2. TUSCAN VILLAGE MASTER PLAN UPDATE 3.0

PLANNING BOARD AGENDA FOR SEPTEMBER 22, 2026 - 7:00 PM

1. **Tuscan Village Master Development Site Plan** – Conceptual Discussion on revised master plan for Tuscan Village to include 120-key hotel, 392 apartments, 72 workforce housing units, medical office, general office, bank, and restaurant uses at 14-24 Tuscan Blvd, Map 107, Lot 12605. Continued from 7/28/2026.

TUSCAN VILLAGE MASTER PLAN UPDATE

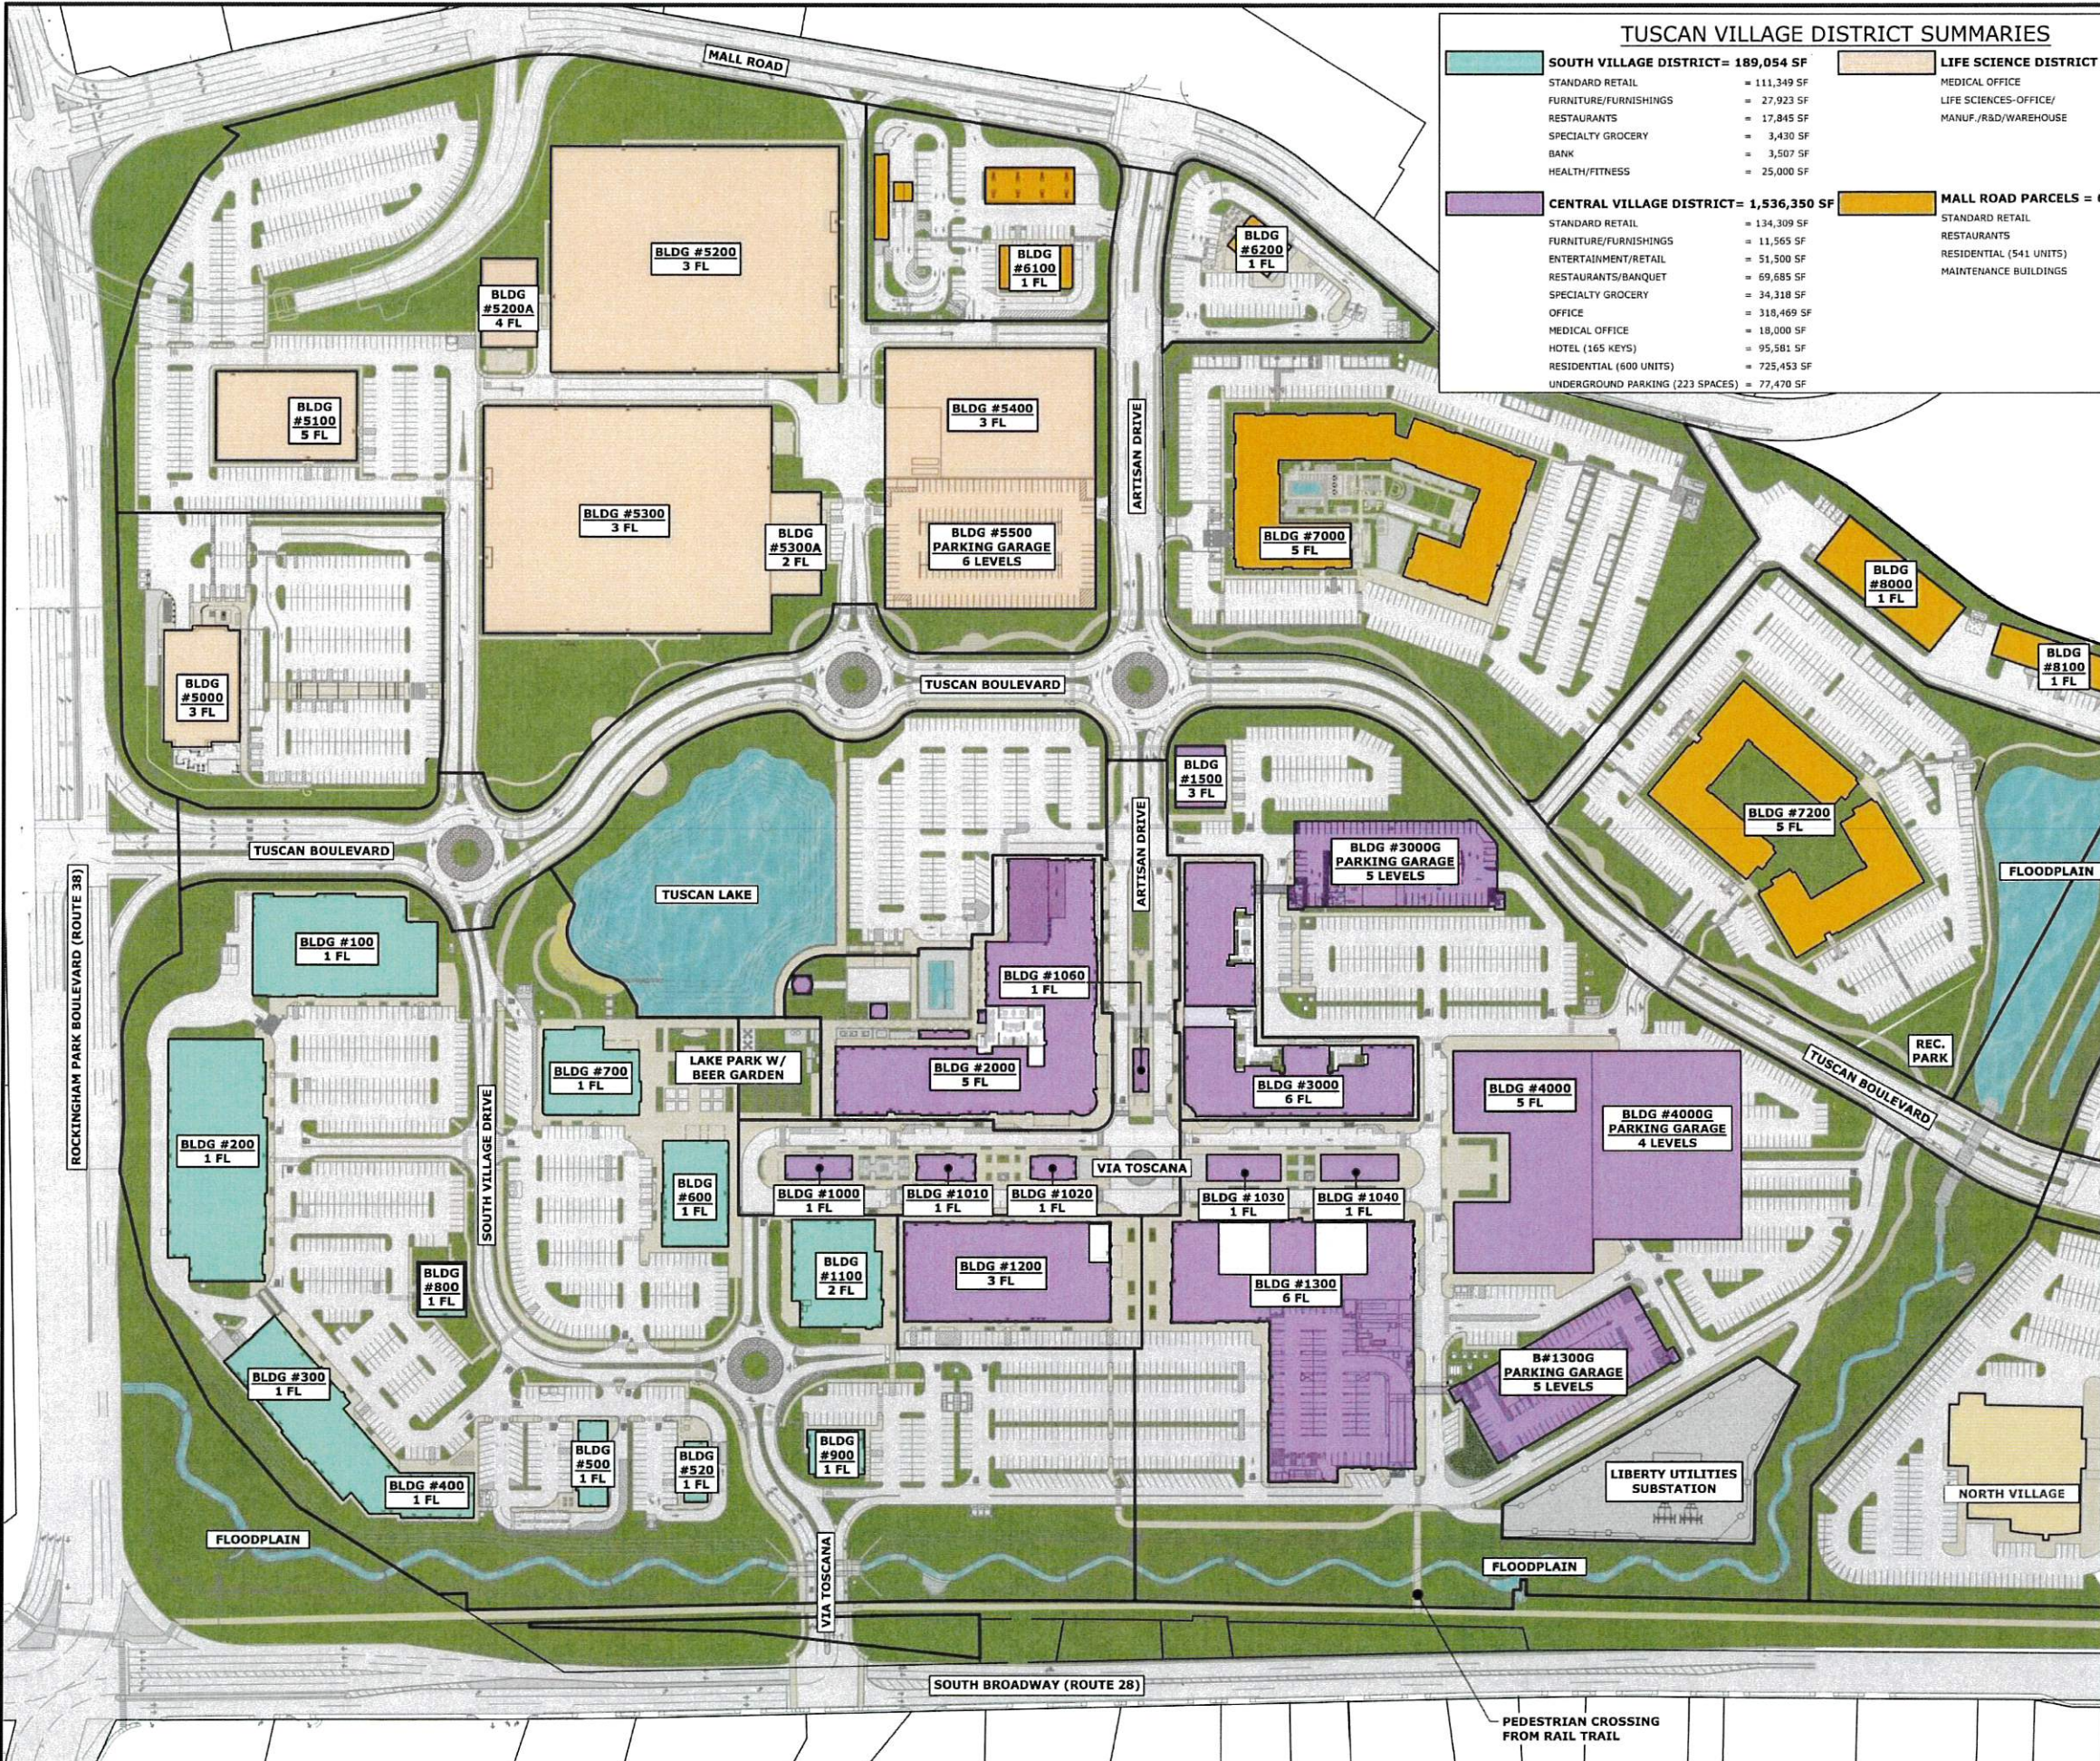
- Sheet 2 – Previously approved Master Plan 2.0
The tabulation in the upper right-hand corner of this Sheet does not add up to 3,632,553. It appears that the restaurant/banquet space should be changed from 87,530 to 92,530 sf.

Response: All these sheets have been updated accordingly. The sf areas in some of the districts have been updated based on changes of use in those areas. (i.e in the South Village District the restaurant in B 800 is now retail). The listed Restaurant/Banquet space listed on Sheet 2 has been adjusted to 92,350 sf such that the sum of all uses equals 3,652,553. The values within District Summary and Building Use Summary tables on Sheet 3 have been revised to be consistent with the tables on Sheet 5 for all districts. The GFA shown within the footprint of Building 5000 on Sheet 4 has been adjusted to 62,415 sf. The GFA shown within the footprint of Building 5000 on Sheet 6 has been adjusted to 62,415 sf. See attached updated Sheets 2-7.

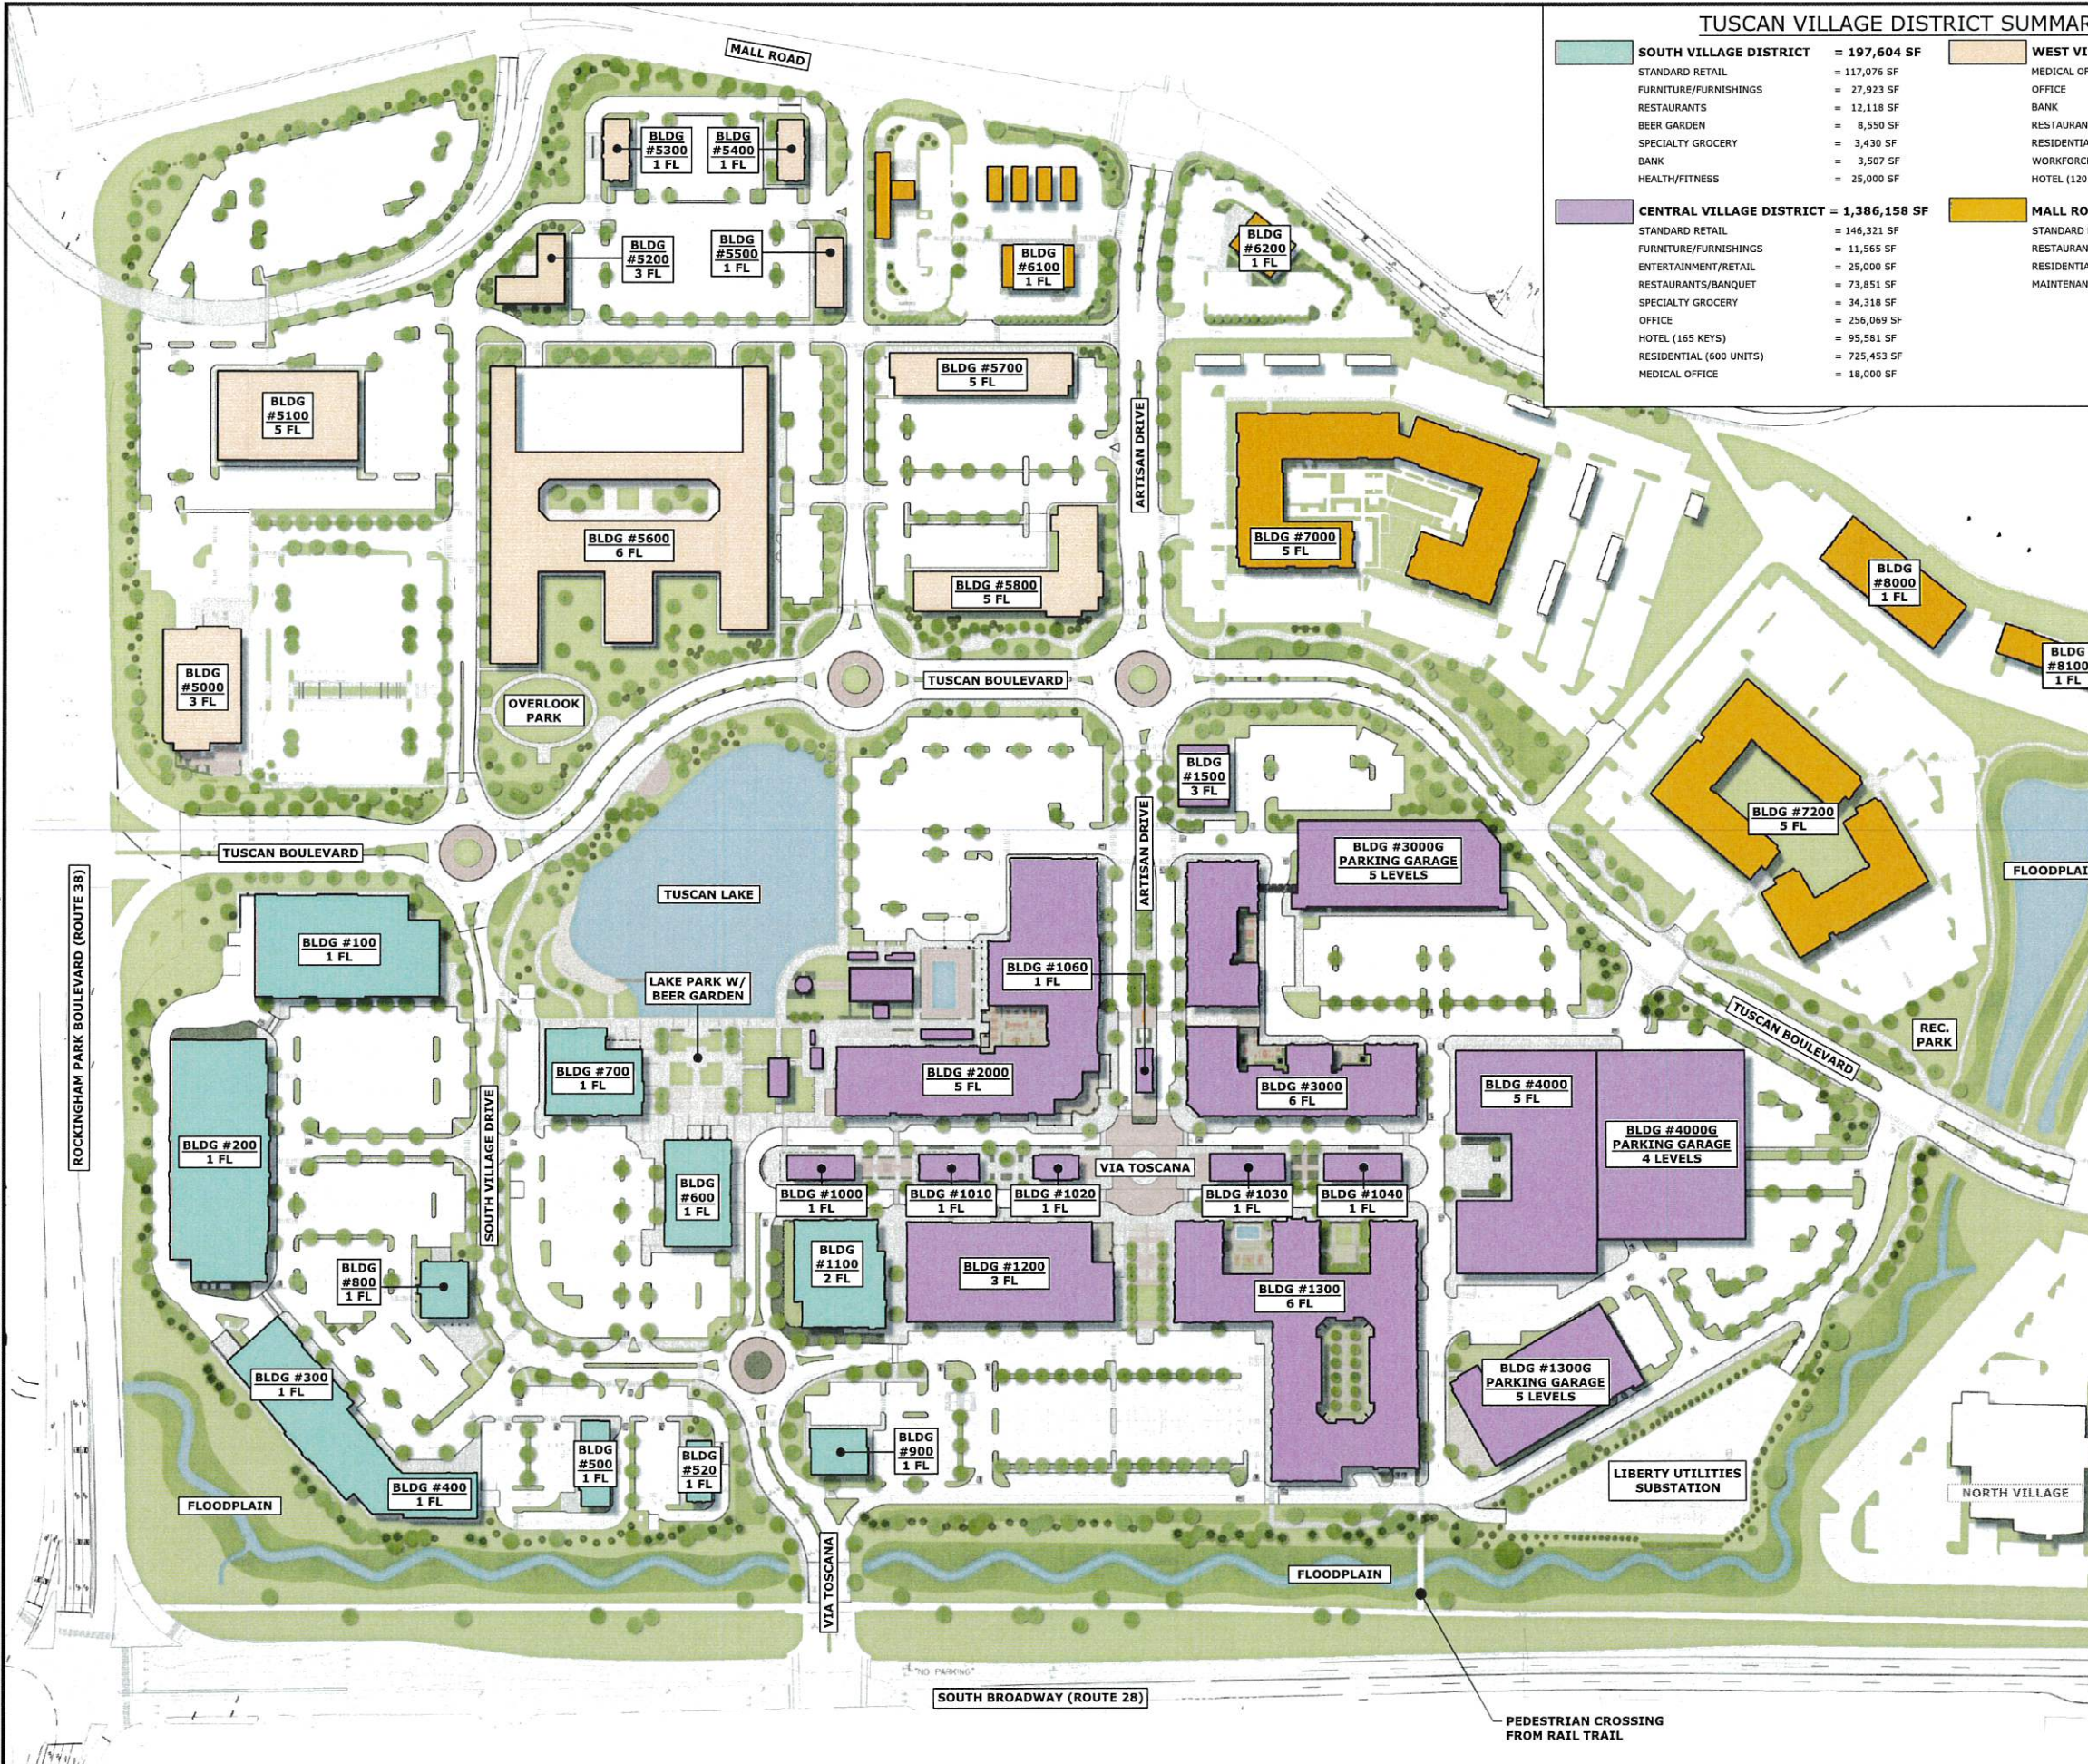
- Sheet 3 – Master Plan Overview
The total gfa for the Central Village District should be changed from 1,446,966 to 1,446,511 for the math to add up and to be consistent with Sheet 5.
- Sheet 4 – West Village District
The table in the upper right-hand corner is not consistent with the information on the plan view. The gfa for Building 5000 should be changed from 63,000 to 62,415 sf for consistency with Sheet 5.
- Sheet 6 – Parking Plan
The gfa for Building 5000 should be changed from 63,000 to 62,415 sf for consistency with Sheet 5.
